March 8, 1973

This is in response to your letter of February 15 concerning the proposed park for Block C of the South Auditorium Urban Renewal Project. You have requested approval of the preliminary plans and arrangements for property transfer as has been discussed in previous meetings.

This is to advise you of the present status of the park proposed for Block C of the South Auditorium Project and to request approval of the Bureau of Parks and the Department of Public Safety regarding preliminary park plans and arrangements regarding property transfers involved.

American Plaza Plan Review - Parcel C-2

PRELIMINARY
SECOND AVE. MALL & PARK # 1 PERS 73
6 PERS 73
7 PERS 75

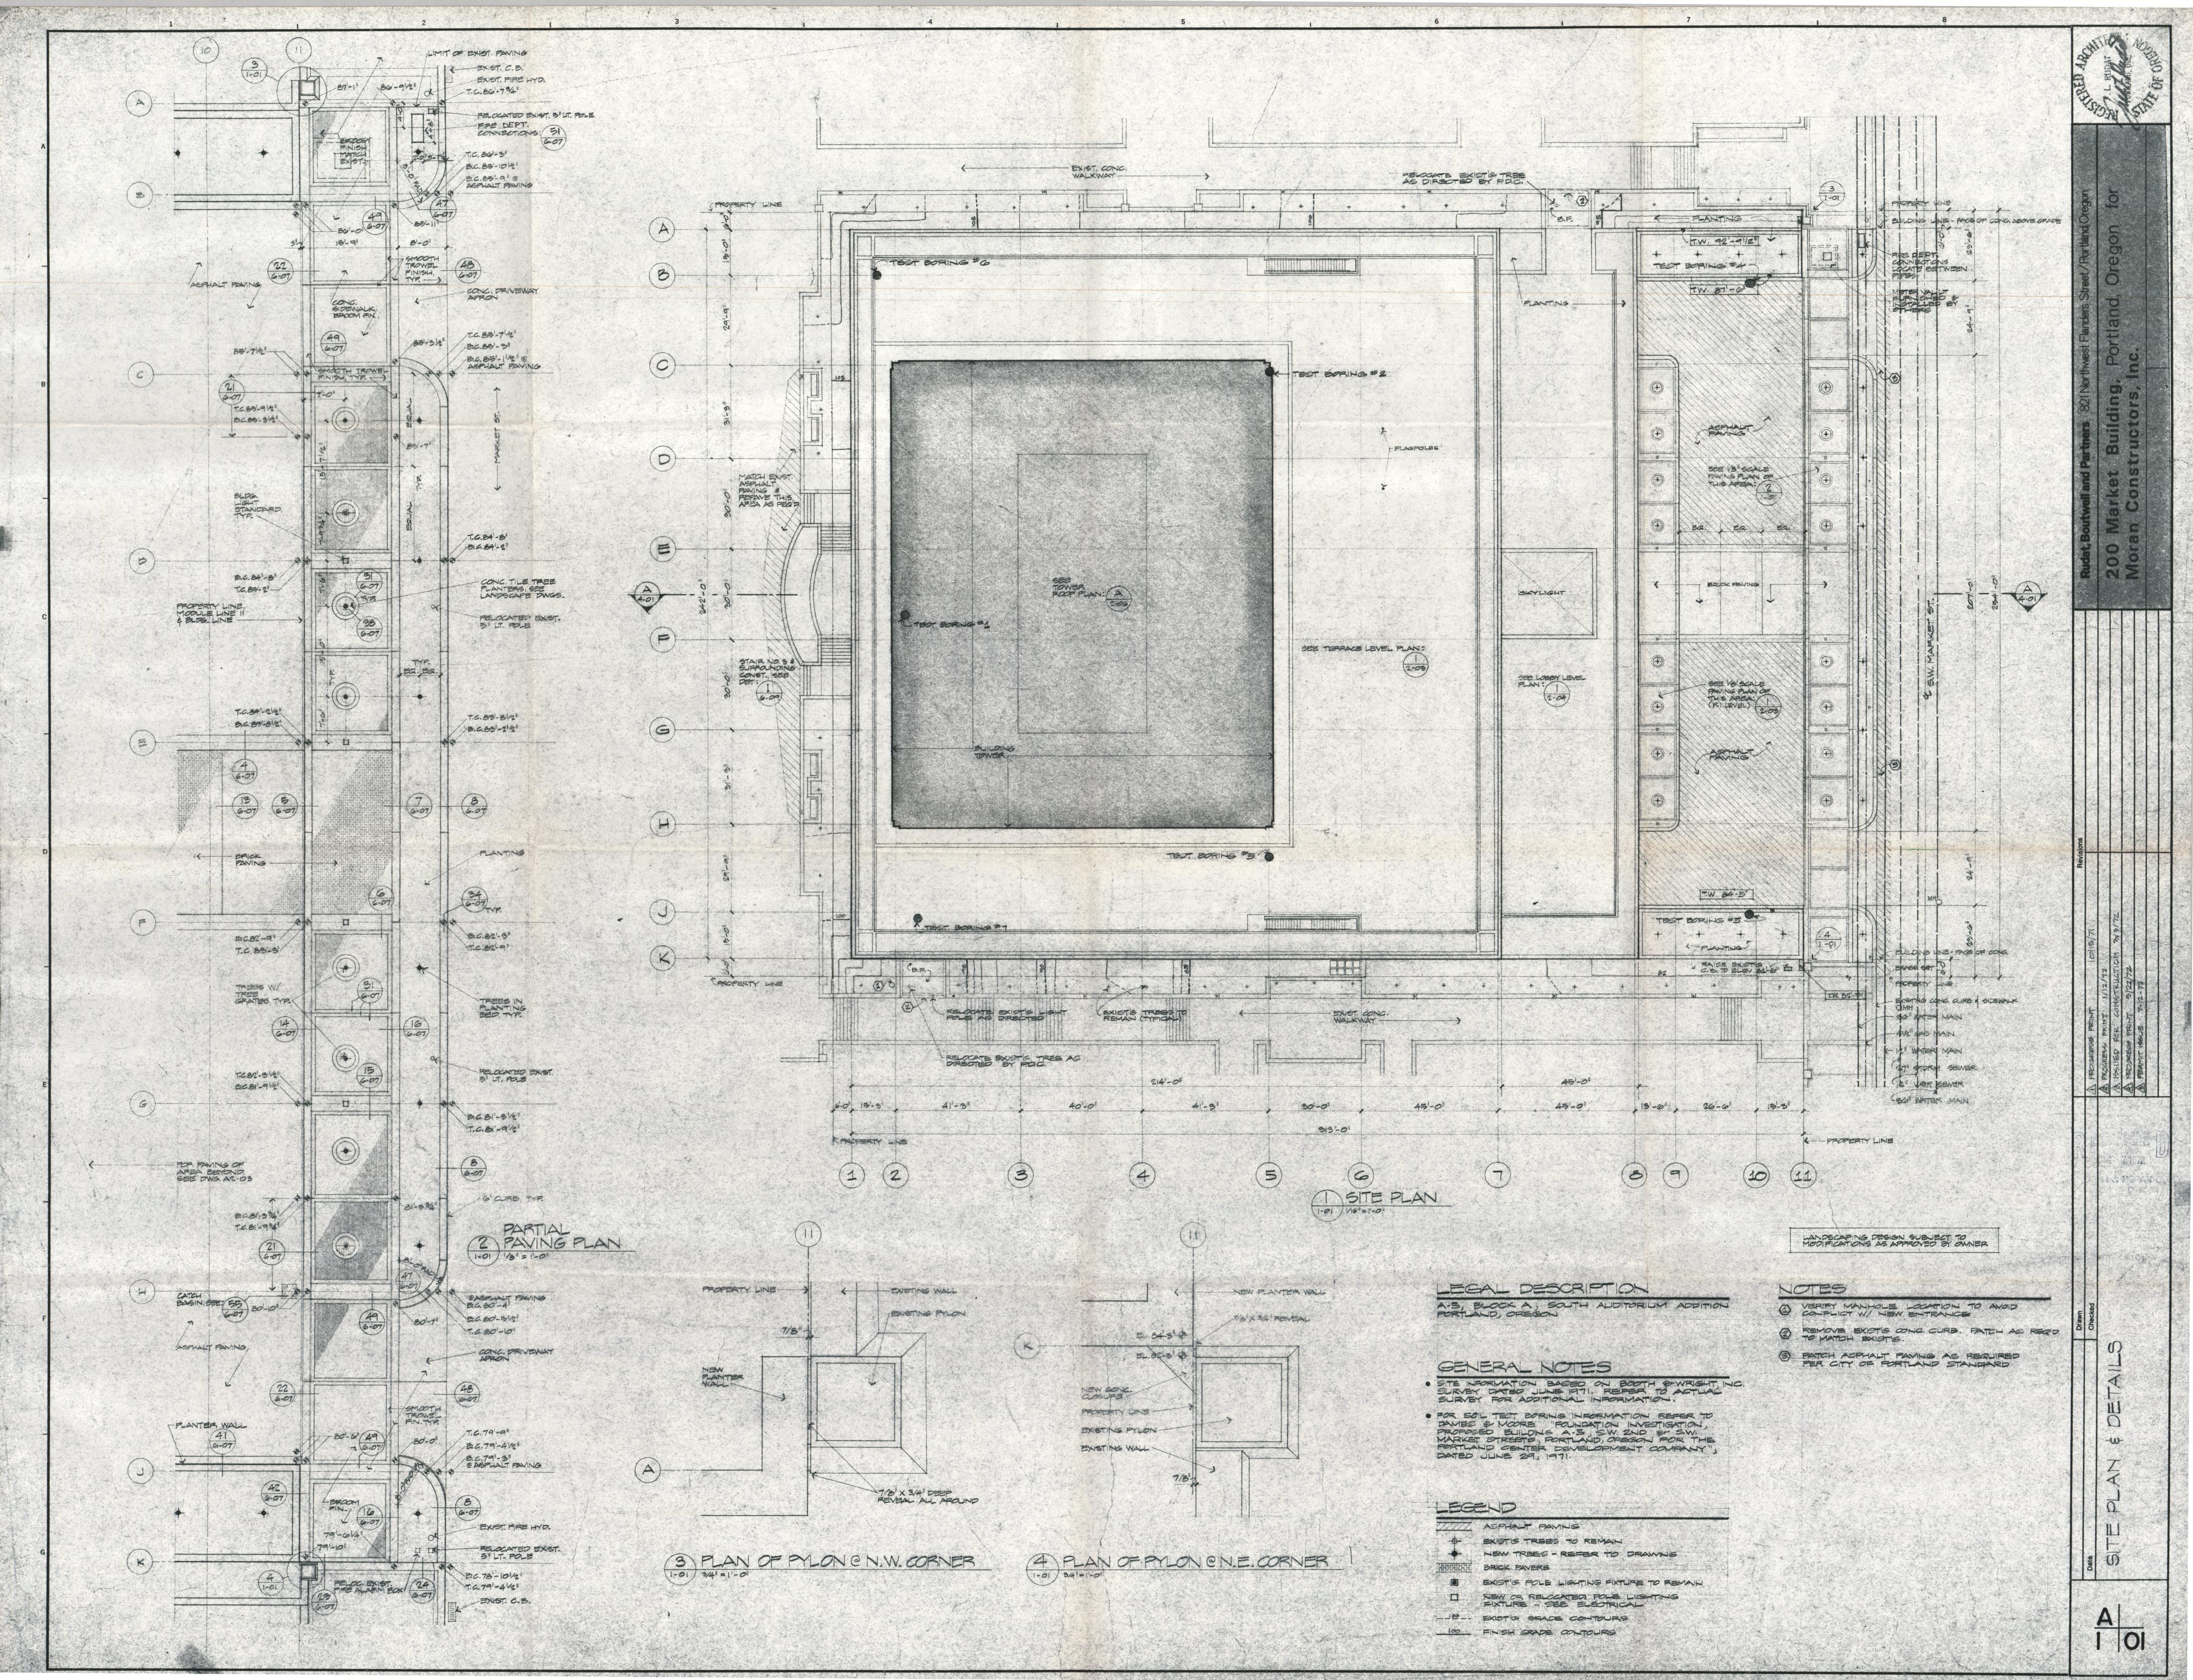
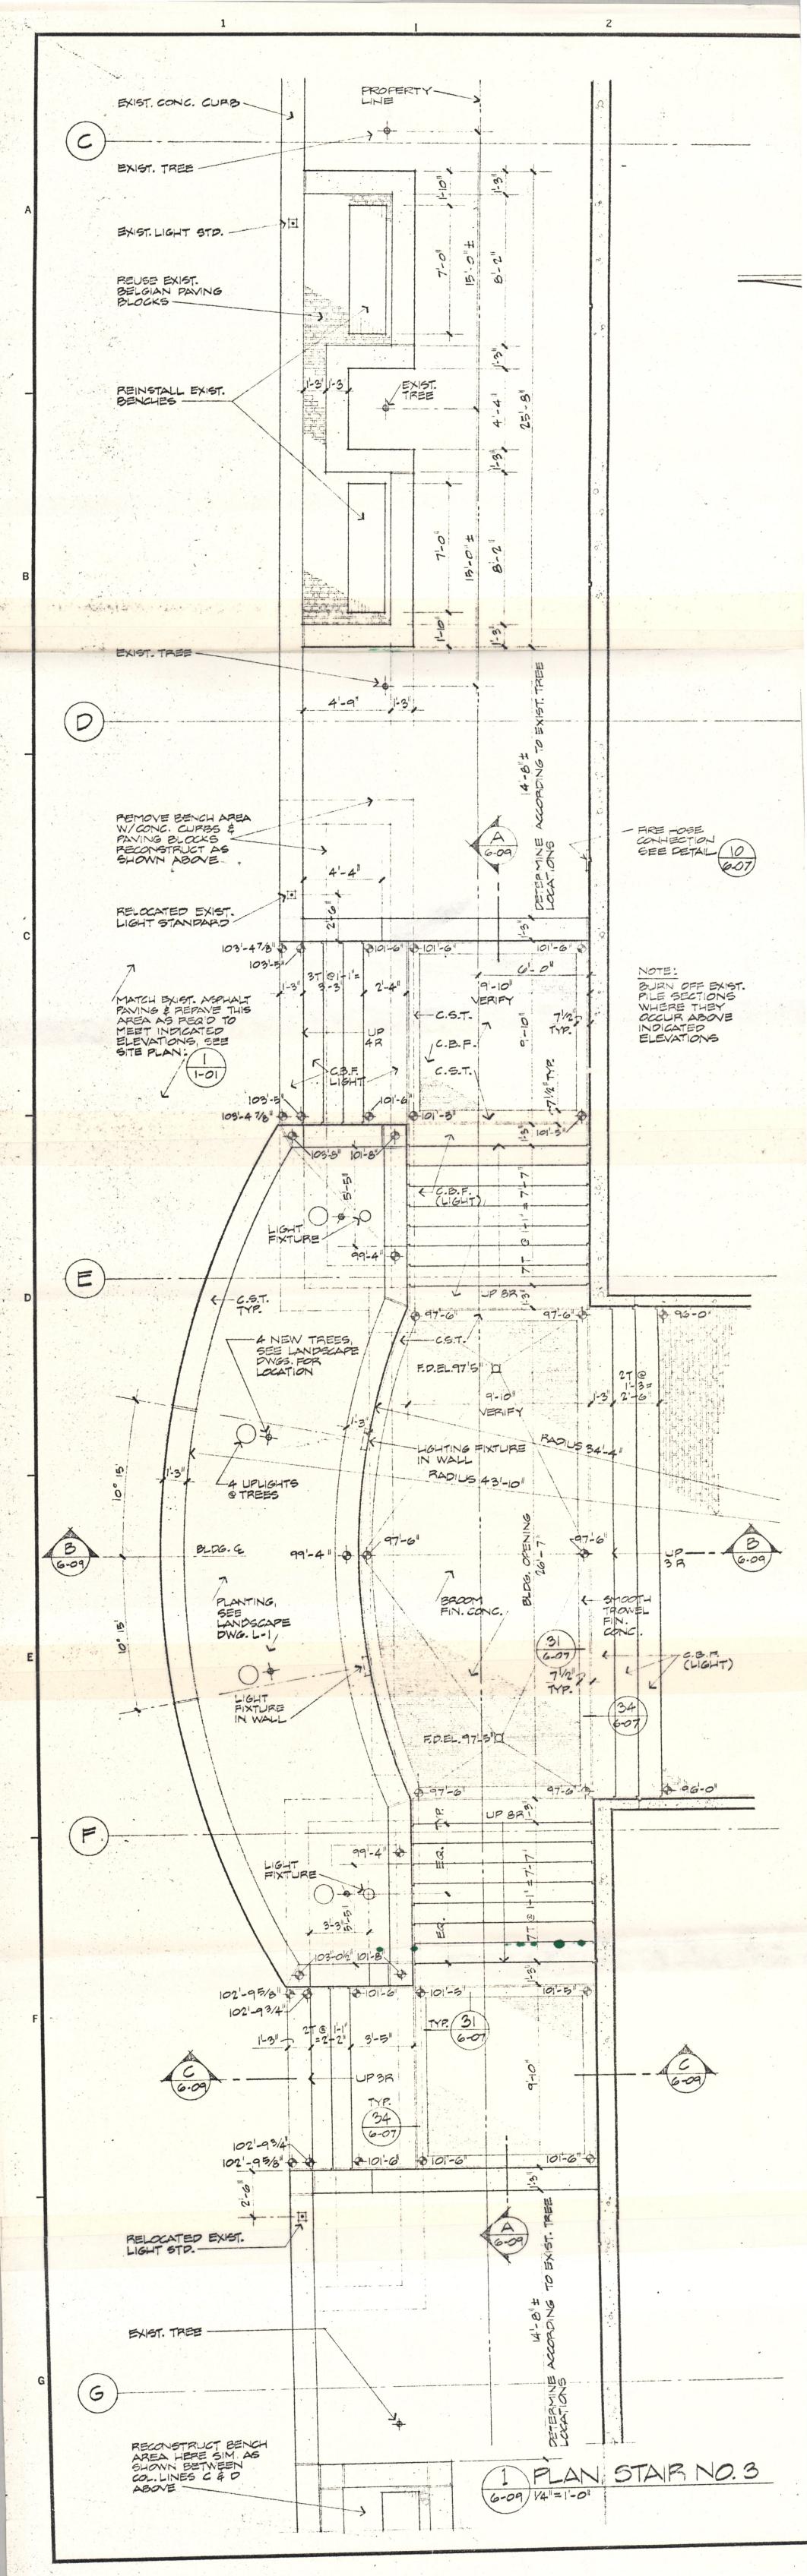
It has also occurred to me that no provision has been made for public restrooms. We know from past experience at the Auditorium Forecourt and the Lovejoy Fountain that the lack of restrooms has presented a significant problem. Accordingly, it is requested that serious consideration be given to including public restrooms in the new park.

The construction estimate for the park area is greater than the budget allowance and will require further study to determine our ability to cover these added costs. It may be best to develop an alternate plan should the needed additional funds not be found by the time the park is to be constructed. We will be prepared to discuss this at our next meeting as well.
